ENVIRONMENTAL PROTECTION AGENCY**40 CFR Parts 63, 264 and 266**

NESHAP: National Emission Standards for Hazardous Air Pollutants: Standards for Hazardous Waste Combustors (Reconsideration)**AGENCY:** Environmental Protection Agency (EPA).**ACTION:** Proposed rule.

Figure 2. NIC and CPT Plan Time Line - New Units

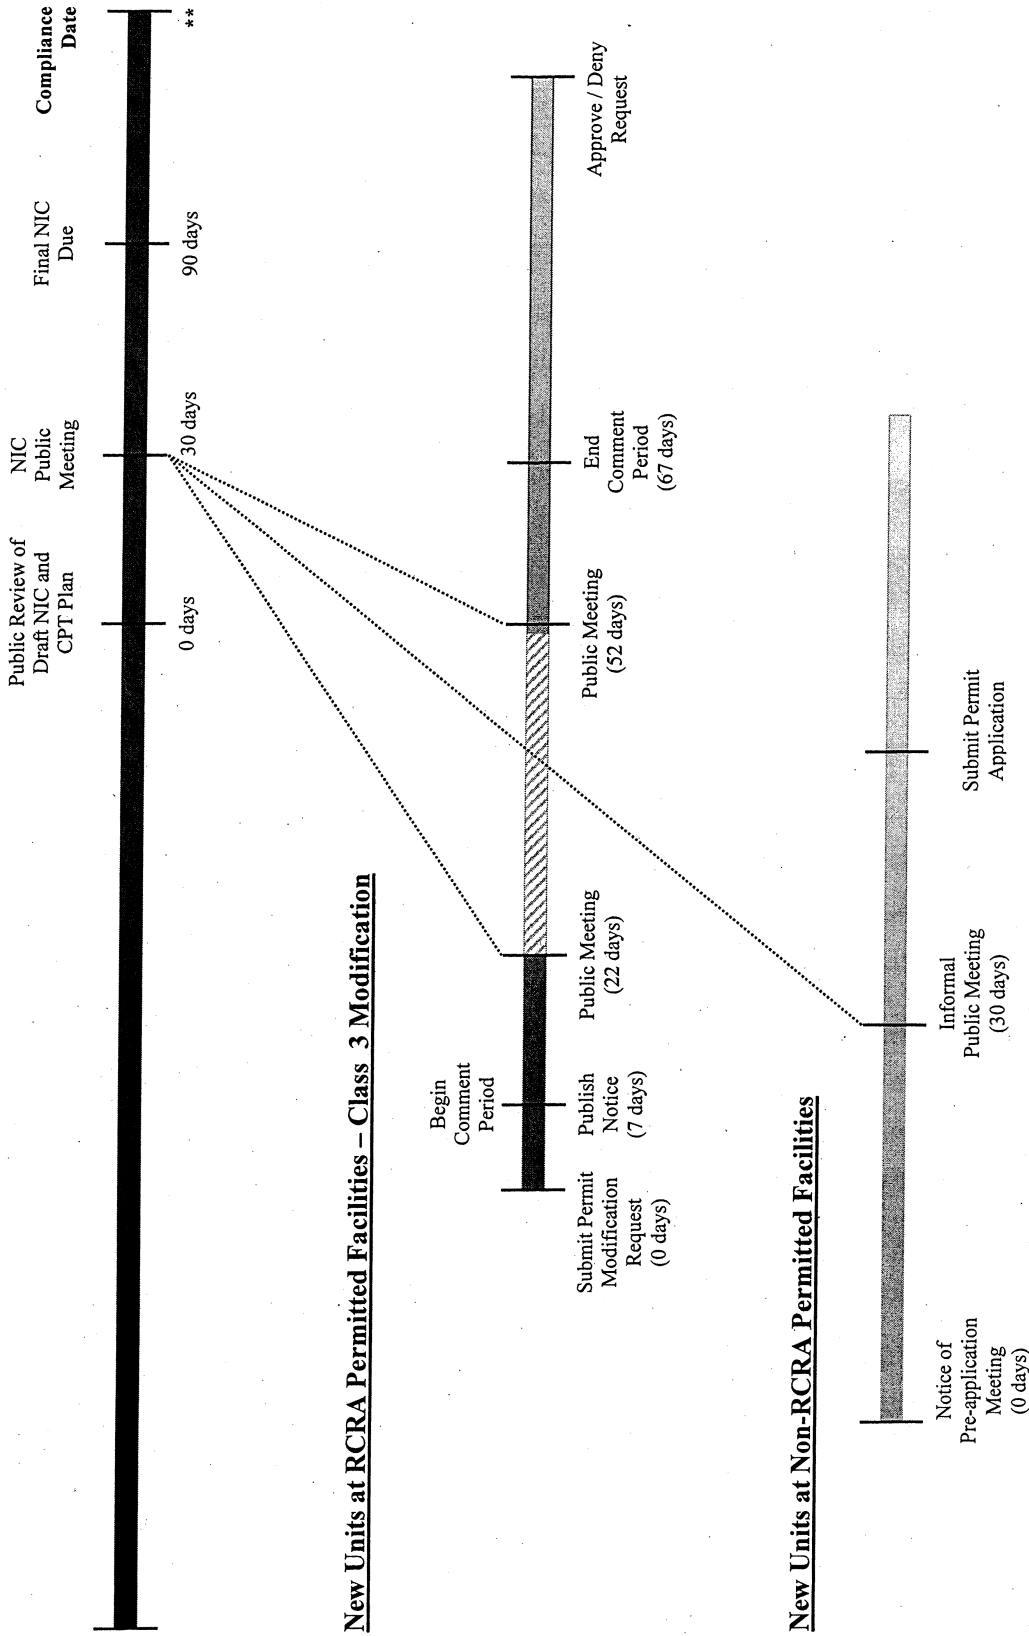
In regard to Figure 2, we have removed the dates from the time line, since they would not be representative of a new unit's compliance deadlines. A new unit's compliance activity deadlines are based on when it begins operations, which is the unit's compliance date and the date it must place a Documentation of Compliance in the operating record. Thus, the effective date of the rule is not applicable to new units and consequently, the Notice of Intent to Comply (NIC) provisions in §§ 63.1210(b)(3) and (c)(1) that specify a deadline based on the effective date of the rule, also would not apply. Since we have always intended that new units follow the same NIC procedures as existing units, we have revised §§ 63.1210(b)(3) and (c)(1) to also include the period of time between the NIC activities so that they correctly apply to both existing and new units. (See Section VII.C (Clarifications to the NIC Provisions for New Units) below for additional discussion.) The time line now reflects the period of time that elapses between public review of the draft NIC and CPT plan, the NIC public meeting, and the final NIC submission deadline. Aside from the corrections

While revising the time line for new units (see Figure 2 shown above in Section VI (Revised Time Lines)) it became apparent that we overlooked the fact that the final rule's effective date has no bearing on new units. A new unit's compliance activity deadlines are based on when it begins operations, which is the unit's compliance date and the date it must place a Documentation of Compliance in the operating record. Therefore, the NIC deadlines are only based upon each individual NIC compliance activity. For example, the clock will begin when the new unit provides the draft NIC and draft CPT plan to the public for review. Once the draft NIC and draft CPT plan are made available for public review, the combined public meeting must occur 30 days later, followed by the final NIC submission an additional 60 days later. Since the public meetings for the NIC and the RCRA pre-application or modification request must occur simultaneously, we anticipate that the new unit will plan accordingly and work with its permitting authorities to determine the most suitable time to begin the NIC compliance process.
